Re: Data Request Set No. 4 for the PG&E Vierra Reinforcement Project, Application No. 18-06-004

Vierra Reinforcement Project Data Request Set No. 4

REV	DESCRIPTION	DATE	DRAWN	ENGINEER
HOWLAND ROAD SINGLE LINE SKETCH

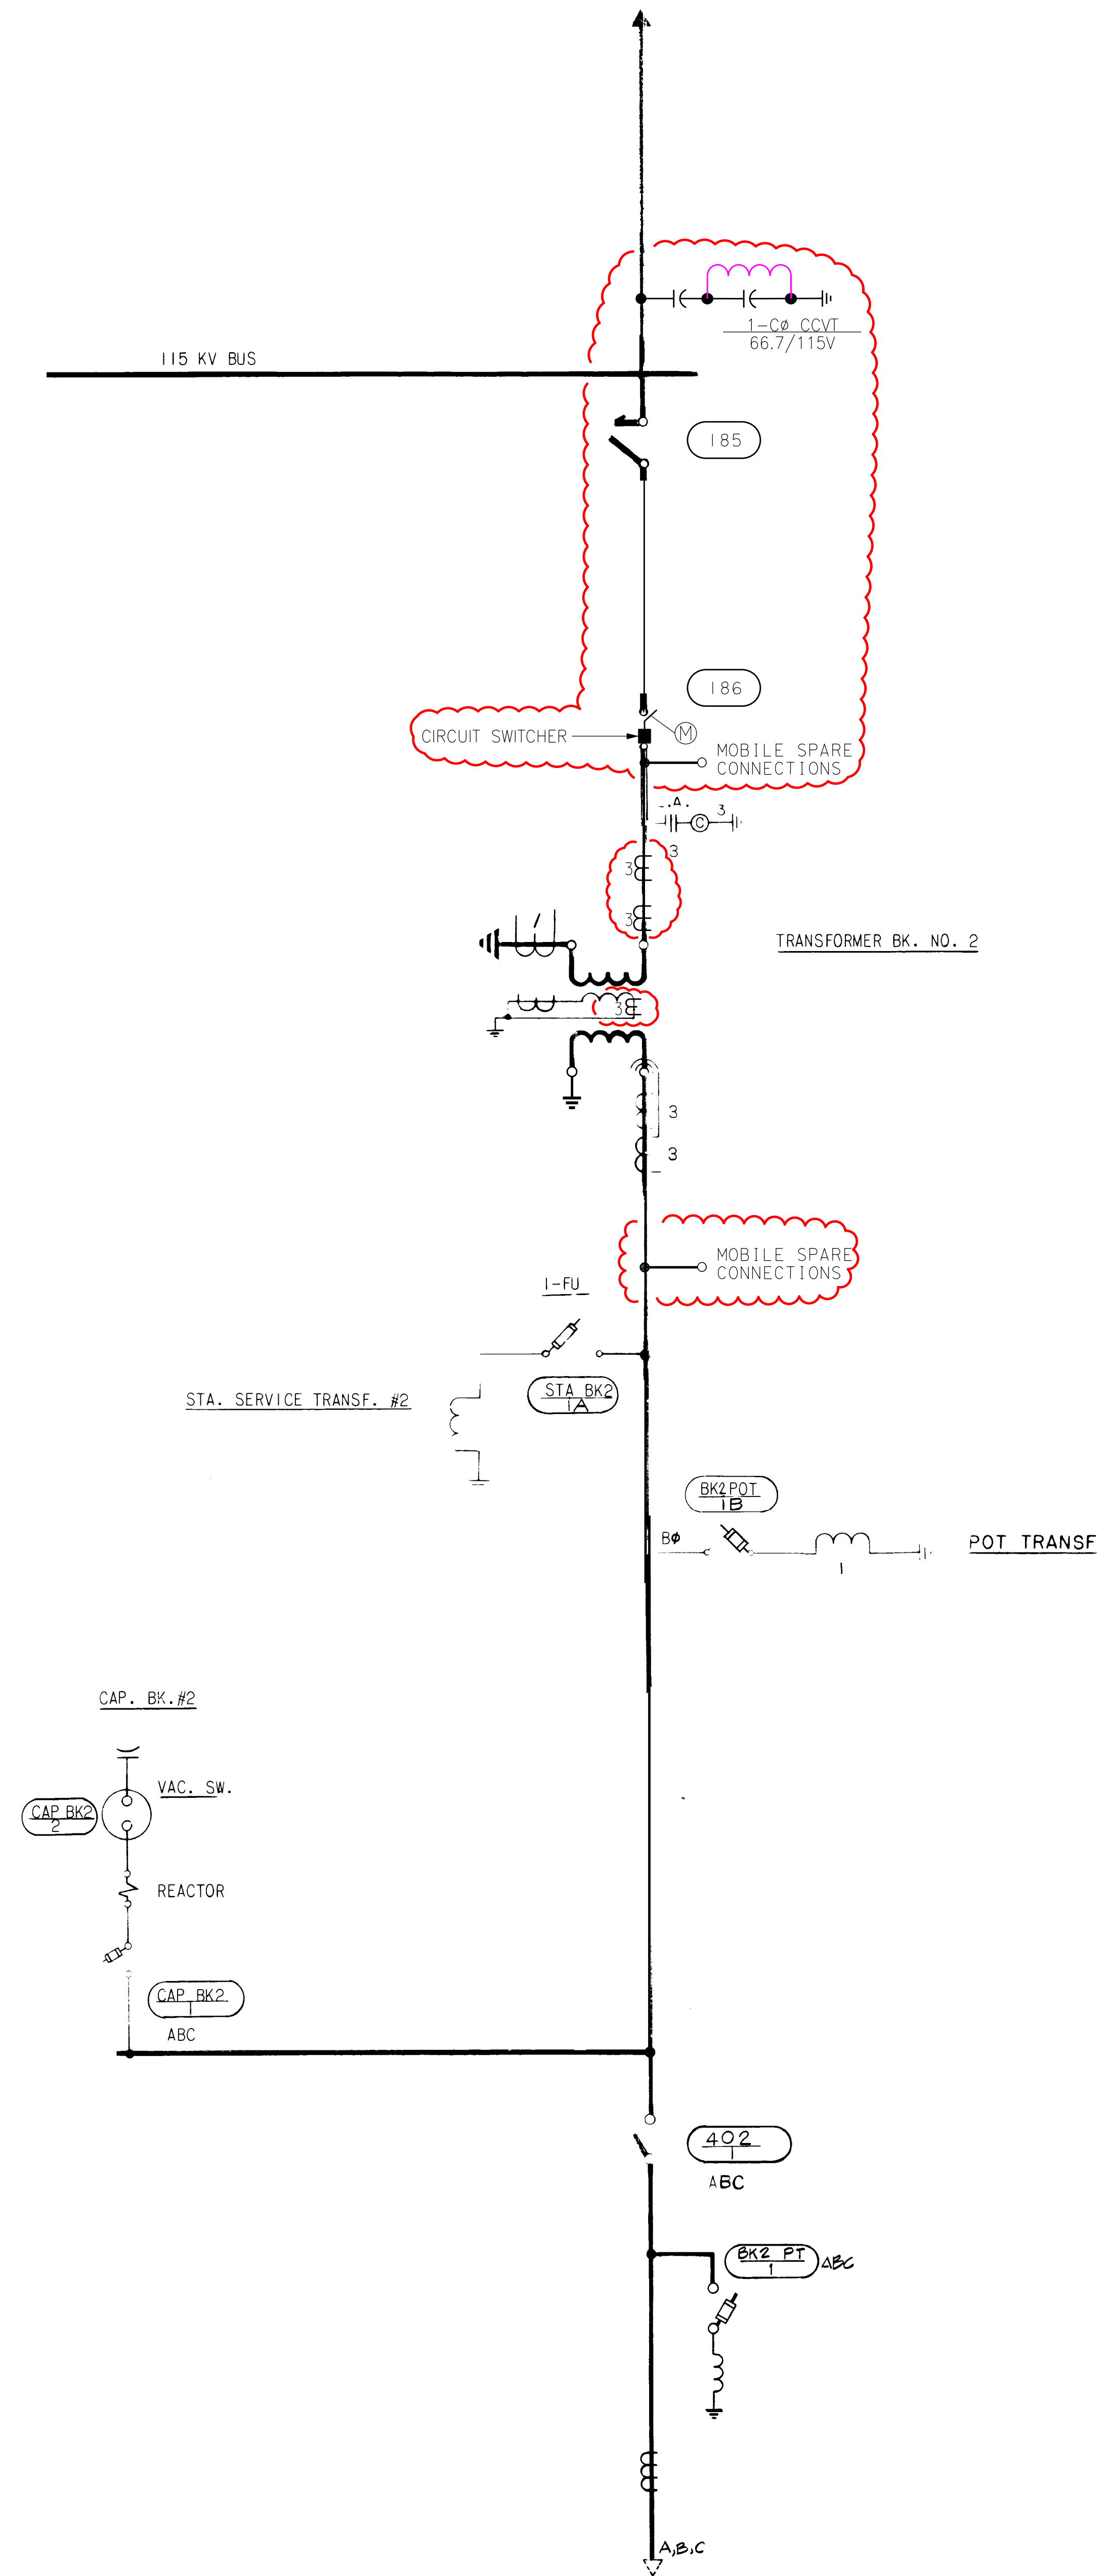
PD-17 CPUC Staff needs more detailed information on the Howland Road Substation modifications. Please provide a one-line diagrams showing the following:

- New voltage transformer primary and secondary side voltages and how it is connected in the Howland Road Substation.
- Indicate where the new proposed circuit switch is located in the one-line diagram.
- Provide a duct bank design configuration and how it is routed to the control room.

Provide the conductor type, size, and current carrying capacity of the existing Howland Road line.

Attached is a single-line diagram of modified connections at the Howland Station).
